ADDENDUM NO. 2

South Putnam High School Track and Field Renovation

Project No. 222152.06

Date: February 23, 2024

1 ELECTRICAL SITE PLAN
1" = 20'-0"

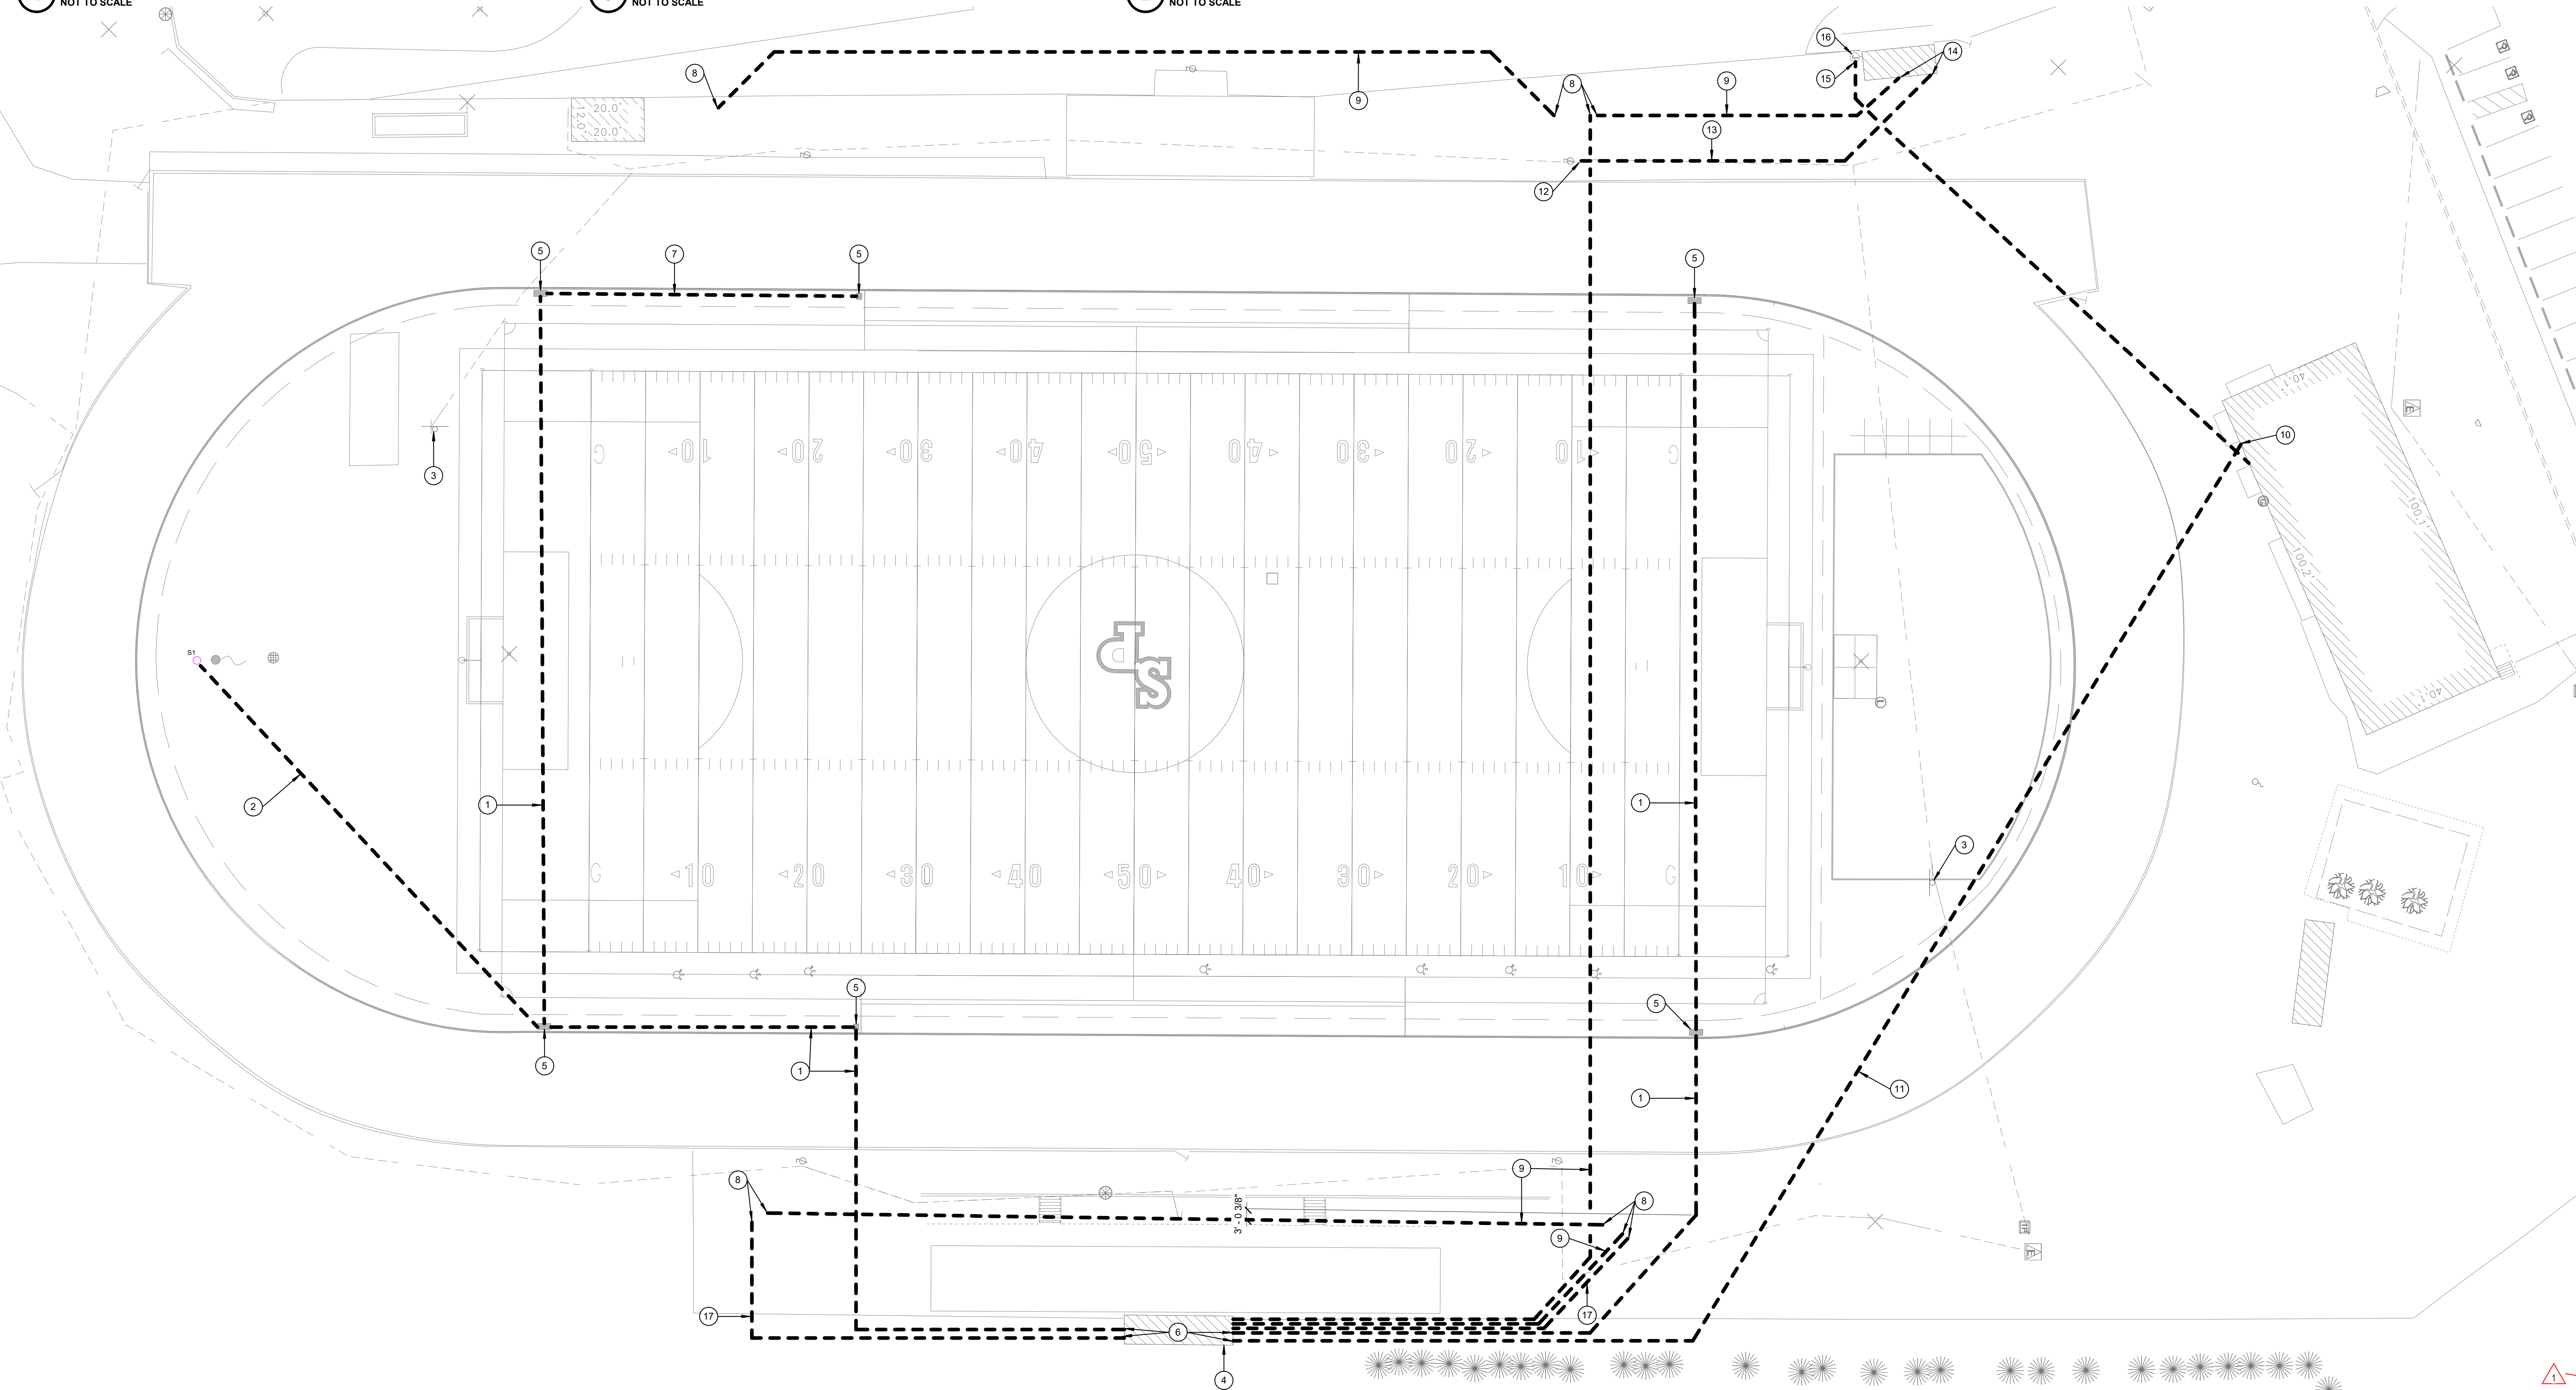
- A. Drawing Sheets: Index, G1.00, and ES101 have been revised, dated 2/22/24, and is included with and hereby made a part of this Addendum. These Drawings supersede the original documents.
